Source: Japan
Title: Comments on draft H.310
Purpose: Discussion

This document provides some technical and editorial comments on the Draft Recommendation H.310 (dated 21 Dec. 1995).

56) Section 9, Figure 4

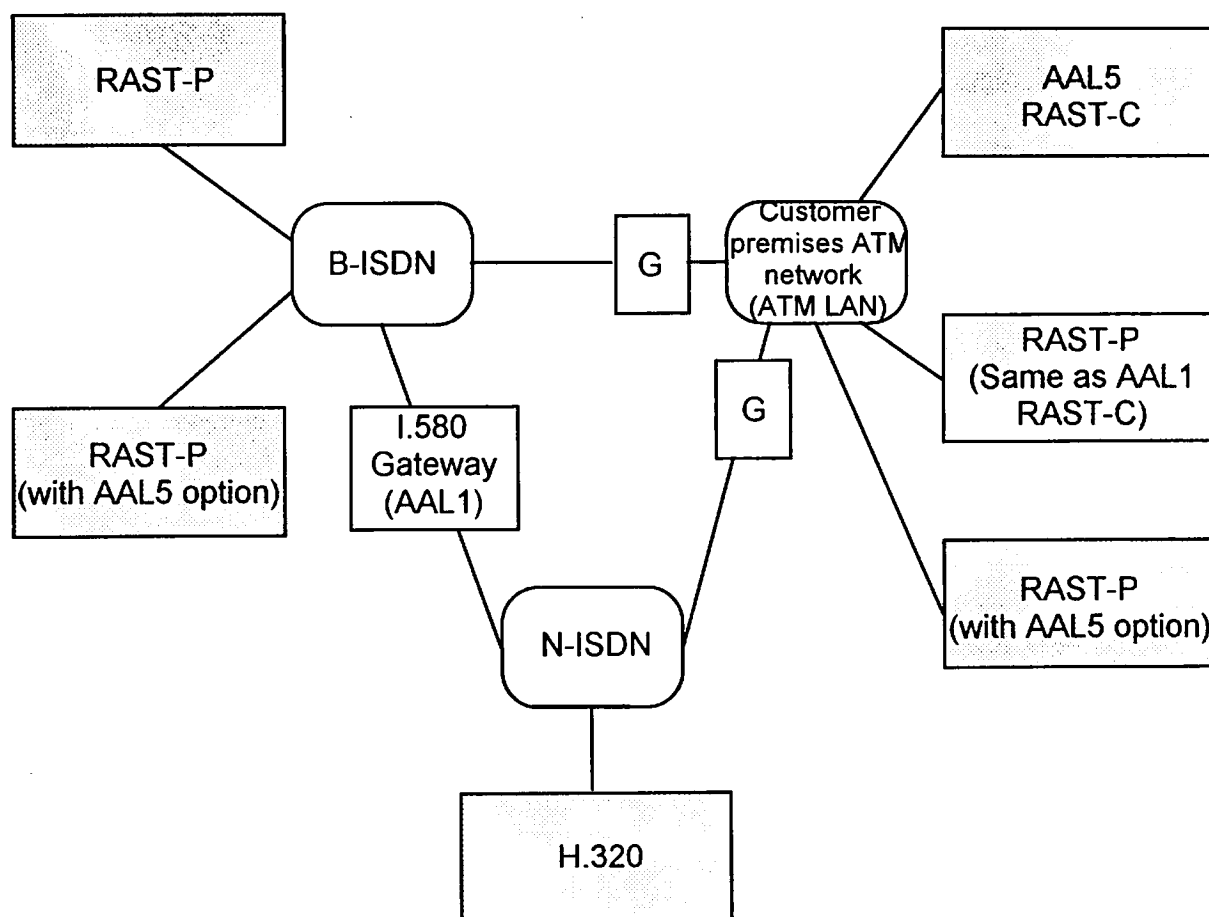
- Allocate three networks at the corners of an equilateral triangle.
- Distinguish between terminal and gateway by different boxes.

A revised diagram is as follows.
